**APPLICATION FOR PERMISSION  
UNDER SECTION 16 OF  
THE TOWN PLANNING ORDINANCE  
(CAP. 131)**

Application No. 申請編號	(For Official Use Only) (請勿填寫此欄)		
Location/address 位置/地址	Lots 347 S.B (Part), 347 S.D (Part) and 348 (Part) in D.D. 109, Kam Tin, Yuen Long, New Territories		
Site area 地盤面積	1,210	sq. m 平方米	<input checked="" type="checkbox"/> About 約
	(includes Government land of 包括政府土地	N/A	sq. m 平方米 <input type="checkbox"/> About 約)
Plan 圖則	Approved Kam Tin South OZP No.: S/YL-KTS/15		
Zoning 地帶	"Residential (Group C)" Zone		
Applied use/ development 申請用途/發展	Proposed Temporary Shop and Services, Eating Place and Public Vehicle Park (Excluding Container Vehicle) for a Period of 5 Years

**(S.16 Planning Application No. A/YL-KTS/1088)**

Departmental Comments		Applicant’s Responses
<b>1. Comments of the Chief Engineer/Mainland North, Drainage Services Department (CE/MN, DSD)</b>		
(a)	The size and gradient of the proposed/existing drainage facilities to be discharged from the site and/or the overland flow intercepted from the adjacent lands should be indicated in the drainage plan. The applicant should check and ensure the hydraulic capacity of the existing drainage facilities would

**FIGURE NUMBER**  
 FIGURE 3

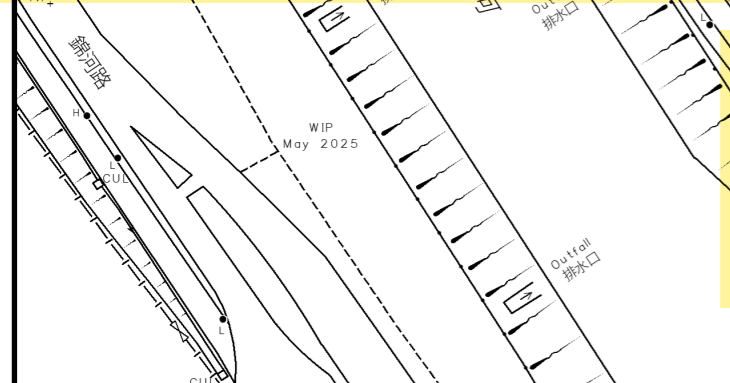
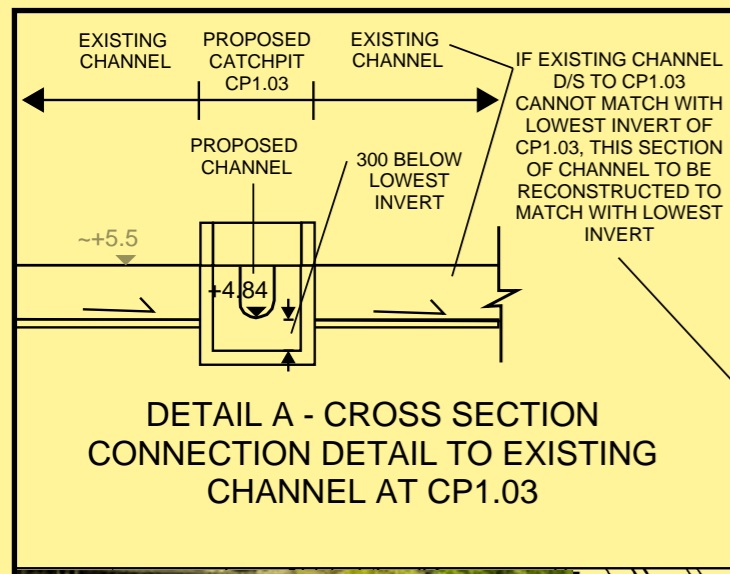
drains/channels and/or modifying/upgrading existing ones in other private lots or on Government land outside the application site.	
(g)	Connection details at discharge point (including cross section) with C.L., I.L and catchpit/channel B.L. should be shown in the drawing.	Noted. Please refer to <i>Detail A</i> and <i>Photo A</i> in updated <i>Figure 3</i> for your perusal ( <b>Annex I</b> ).

**FIGURE NUMBER**  
**FIGURE 5**

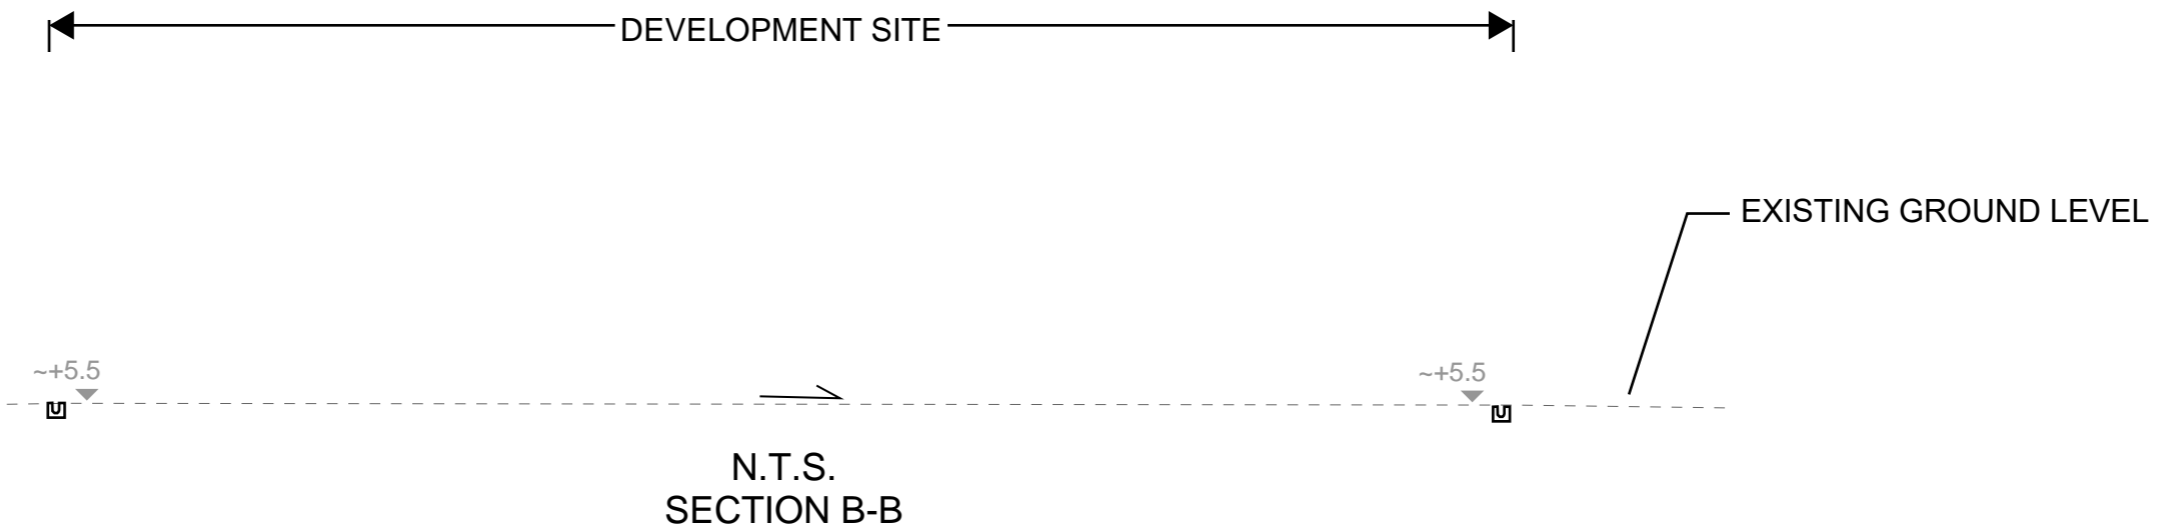
(h)	Please include the existing planter details in section A-A.	Noted. Please refer to updated <i>Figure 5</i> ( <b>Annex I</b> ). Please kindly note that the existing planter level is about the same level of existing paved area. Overland flow would not be obstructed by existing planter.

FIGURE NUMBER  
FIGURE 5

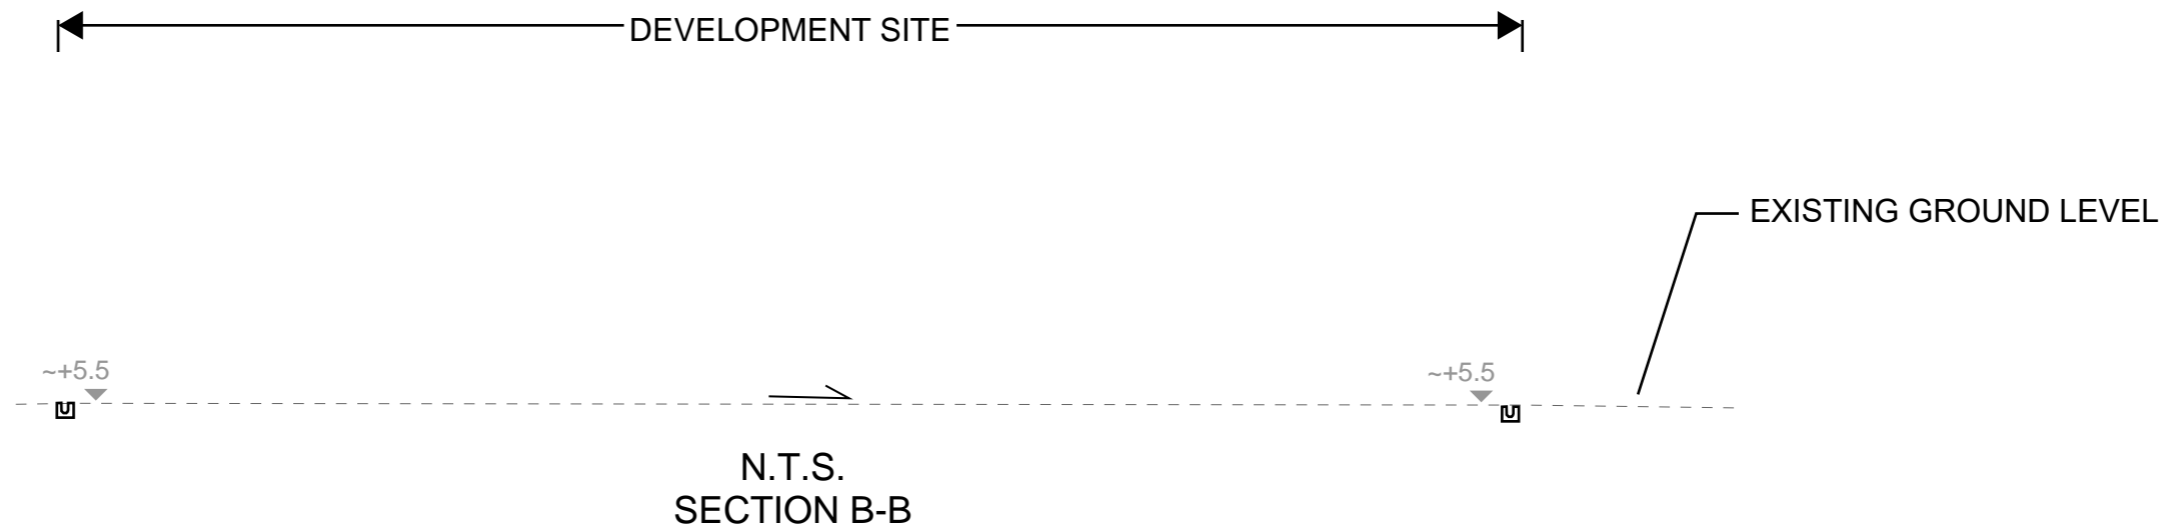
(c)	Please advise if any site formation/levelling works to be carried out under this application. Cross sections showing the existing and proposed ground levels of the captioned site with respect to the adjacent areas should be given.	The applicant intends to keep the existing levels. The cross sections are shown in Figure 5 of the proposal.
